Serial No. **10/731,445**

Docket No. **K-0589**

Reply to Office Action of October 18, 2005

**Amendments to the Drawings:**

FIG. 1  
~~Related Art~~

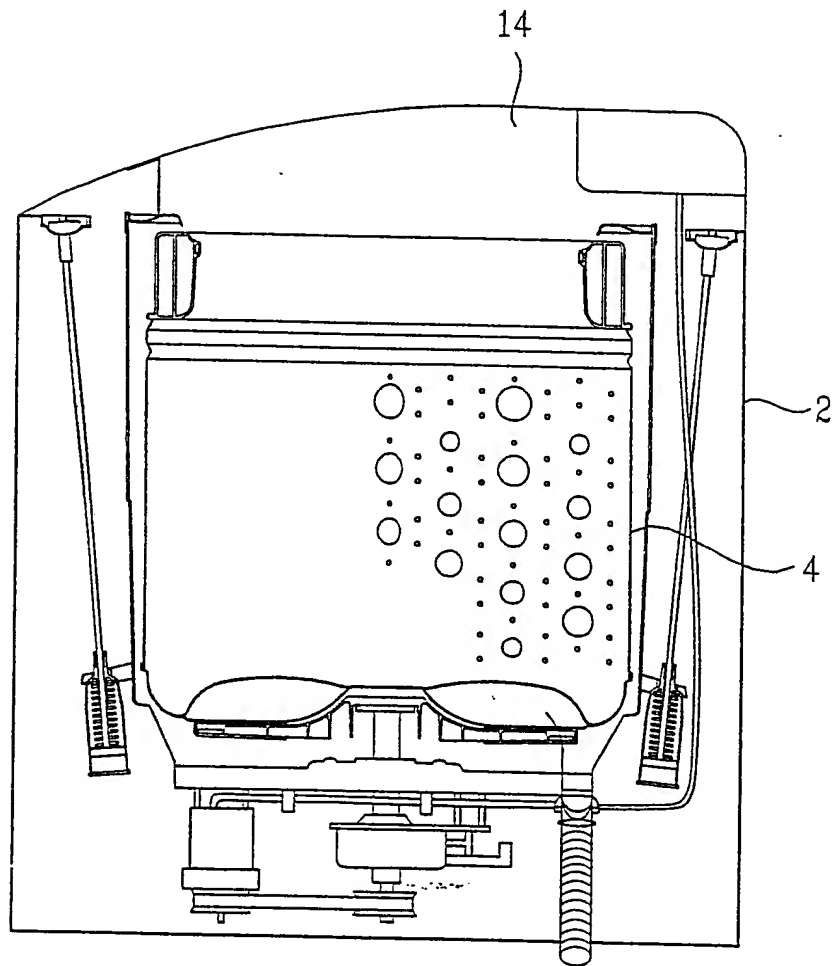
The attached drawings include changes to Figures 1 and 2. These sheets, which include Figures 1 and 2 replace the original sheets including Figures 1 and 2. Figures 1 and 2 have been amended to remove the legend "Related Art."

The Office Action objects to the drawings under 37 CFR 1.83(a), alleging that the “cabinet for a home appliance” recited in claims 1 and 7, and the “cabinet of a home appliance having a sectioned lid” recited in claim 12 are not shown in the drawings. Applicants respectfully disagree.

The home appliance shown in Figures 1 and 2 of the present application includes a cabinet 2 with a sectioned lid 14, the sectioned lid 14 including front and rear lids 15 and 16, respectively. Figure 3 is a cross section of a related art rear lid 16 used in the home appliance, taken along line A-A of Figure 2, which is just in front of the rear lid’s hinged attachment to the cabinet 2 of the home appliance (see also paragraph 5 of the present application).

of Figure 2, just in front of the rear lid's hinged attachment to the cabinet 2 of the home appliance (see also paragraphs 15-18 and 20 of the present application). It is respectfully submitted that the "cabinet for a home appliance" recited in claims 1 and 7, and the "cabinet for a home appliance having a sectioned lid" recited in claim 12 are clearly shown in Figures 1 and 2 of the present application, with Figure 4 providing a sectional view of the sectioned lid of the cabinet. To remove any confusion, Applicants are amending Figures 1 and 2 to remove the legend "Related Art" so that it is clear that these figures depict one embodiment of the claimed cabinet.

Further, it is respectfully submitted that Figures 1 and 2 of the present application clearly show a cabinet for a home appliance having a sectioned lid comprising a first section and a second section having a first end hinge-coupled to the first section, as recited in independent claim 12, and a second end hinge-coupled to the home appliance, as recited in claim 13. As set forth above, Figure 2 clearly shows that the sectioned lid 14 includes front and rear lids 15 and 16, and paragraph 5 of the present application explains that the rear lid 16 is hinge-coupled at one end to the front lid, and at its opposite end to the home appliance. It would be well understood by one of ordinary skill in the art, especially when taken in light of Figure 2 and its accompanying description in the specification, that these two portions 15 and 16 of the sectioned lid 14 are hinge-coupled to allow the sectioned lid 14 to function in the manner described (see also paragraph 4 of the present application).
